LIGO Laboratory

Date:	7 May 2008	Refer to:	L080051-01
Subject:	Response to committee comments and questions on Systems Design, T010075-01		
To:	Advanced LIGO Systems PDR committee		
From:	Peter Fritschel, Dennis Coyne

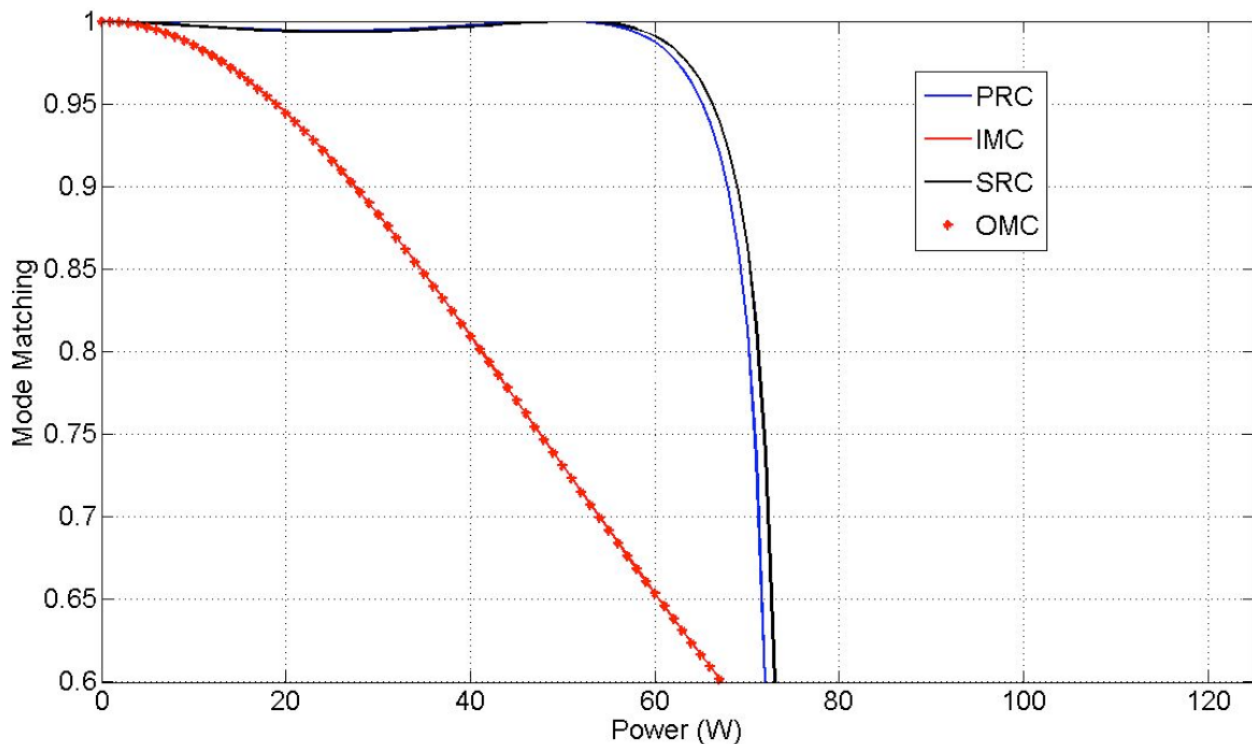
“The approach that currently appears most attractive is to begin operating the interferometer without signal recycling and at a modest power level.” Question: Will this modest power level be sufficiently low that the Thermal Compensation System will not be needed? (EG)

That is the hope. There hasn't been a lot of analysis of this yet, but here is a recent calculation of the effect of the ITM thermal lens, assuming 0.5 ppm of surface absorption (from Muzammil Arain):
